# St. Clair Creek Restoration Project Year 4 Final Monitoring Report

DMS Project ID No. 95015

Subject: Task 10: Response Letter to DMS review comments regarding the Draft Year 4 Monitoring Report for the St. Clair Creek Restoration Project (#95015)  
Beaufort County, North Carolina, Cape Fear Basin – CU#03020104  
DMS No. 95015, Baker No. 125116

### St. Clair Creek Flow Gauge SCFL4 (Upstream UT2)

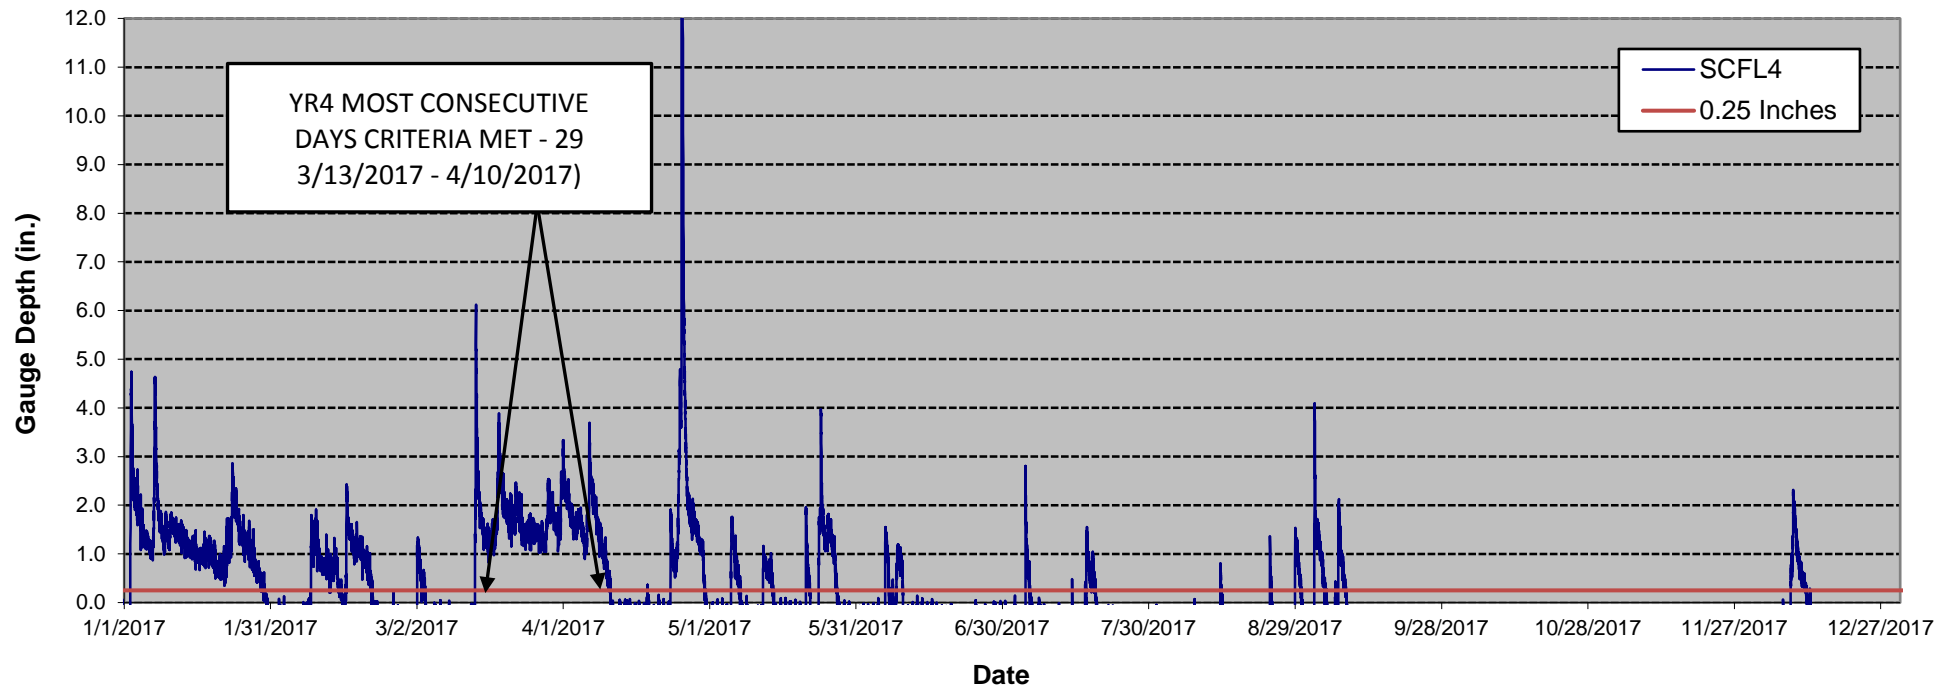
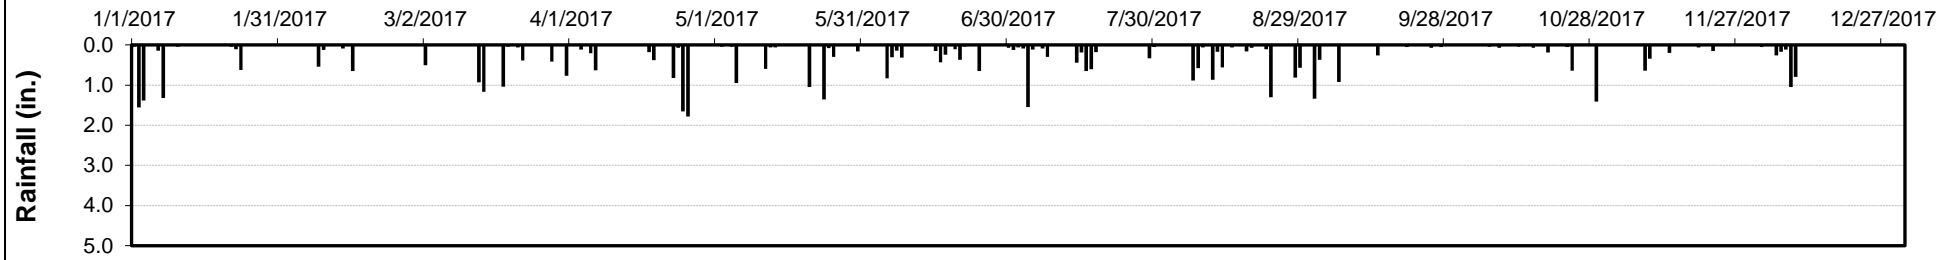
3. Section 2.1.1: Clarify reason/potential reason for flow gauge SCFL#4 not meeting 30 consecutive days of flow requirements and be prepared to discuss at the upcoming credit release meeting. For example, was it due to lower than normal precipitation?

**Response: Flow gauge SCFL#4 recorded separate 29-day and 28-day flow events, but did not meet success criteria of 30-days during the year. The overall rainfall for the site was below the Beaufort County historic average with a 1.7" deficit, and all of the flow gauges experienced reduced duration consecutive-day flow events this monitoring year as compared to last year. However, as**

shown in Table 11 the total cumulative days of flow remained substantial for each gauge (even increasing from previous years in four of the six gauges). As such, it is believed that the specific rainfall distribution pattern observed in 2017 is likely why the consecutive-day values are reduced. In particular, a January where virtually all the rainfall fell in the first week, followed by an extraordinarily dry February (well below the historic 30% probable average) appears to have reduced the number and duration of flow events during the exact time of year where they are generally more prevalent and longer lasting. This late winter to early spring time period is when the site tends to be the wettest and the flow gauges have previously met their success criteria. This discussion was added to the text.
